Bayside Planning Panel

Item No	6.3
Application Type	Development Application
Application Number	DA-2017/403
Lodgement Date	03/07/2017
Property	13-15 Rye Avenue, Bexley
Owner	The Trust Company Limited
Applicant	Mammoth Projects
Proposal	Demolition of existing structures and construction of a two (2) storey childcare centre accommodating 109 children, 24 staff, basement level carpark and signage
No. of Submissions	Six(6) submissions and a petition signed by 37 persons
Cost of Development	\$2,997,774
Report by	GAT & Associates Marta M. Gonzalez-Valdes, Coordinator Development Assessment

PLANNING ASSESSMENT REPORT

Application Number:	DA-2017/403
Date of Receipt:	03/07/2017
Property:	13-15 Rye Avenue, Bexley Lot 11 DP 5207 Lot 12 DP 5207
Owner:	The Trust Company Limited
Applicant:	Mammoth Projects
Proposal:	Demolition of existing structures and construction of a two (2) storey childcare centre accommodating 109 children, 24 staff, basement level carpark and signage.
Recommendation:	Refusal
No. of Submissions:	The development has been notified in accordance with the provisions of Rockdale DCP 2011 and Council received 6 submissions, including a petition signed by 37 persons, objecting

Figure 3 – Drainage Infrastructure

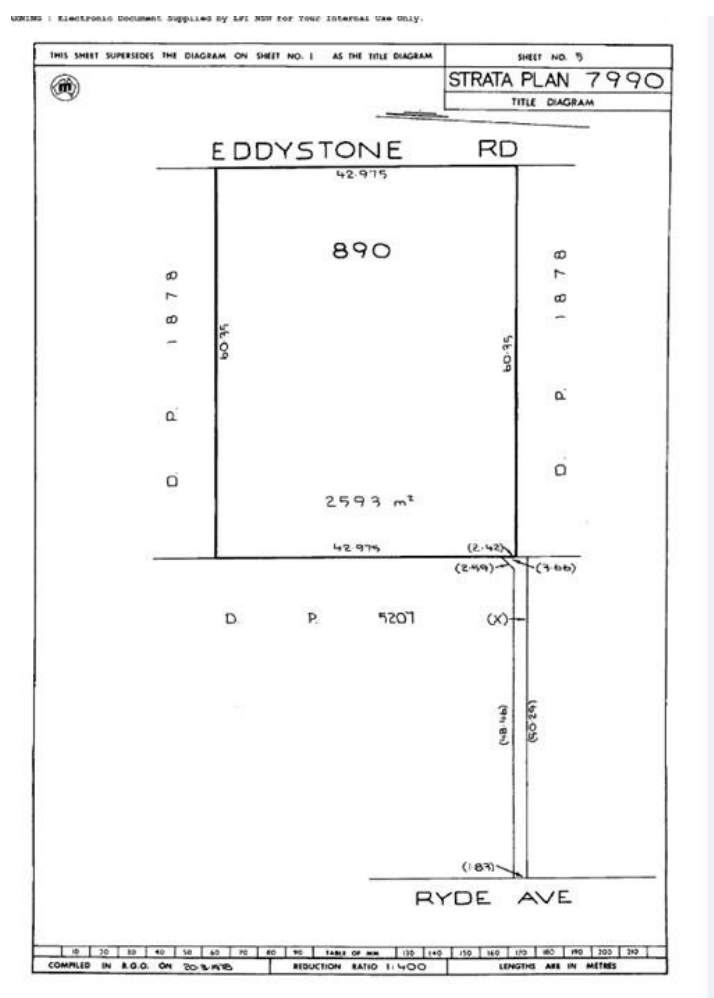
Stormwater drainage concept plans, prepared by Greenview Consulting (dated 28 June 2017) were submitted with this application. These plans have been reviewed by Council's Development Engineer. While the on-site detention system has been deemed generally acceptable, through the assessment process it has been noted that Council's information indicates there is drainage infrastructure and an existing drainage easement between 13 and 15 Rye Avenue. Refer to Figures 3 and 4.

No information on this easement, ownership and the relocation of the easement and infrastructure has been provided to Council. The stormwater plans do not indicate how the upstream runoff can be diverted to avoid detrimental impacts on the site itself and adjoining properties.

Accordingly, insufficient information has been provided and is a reason for refusal.
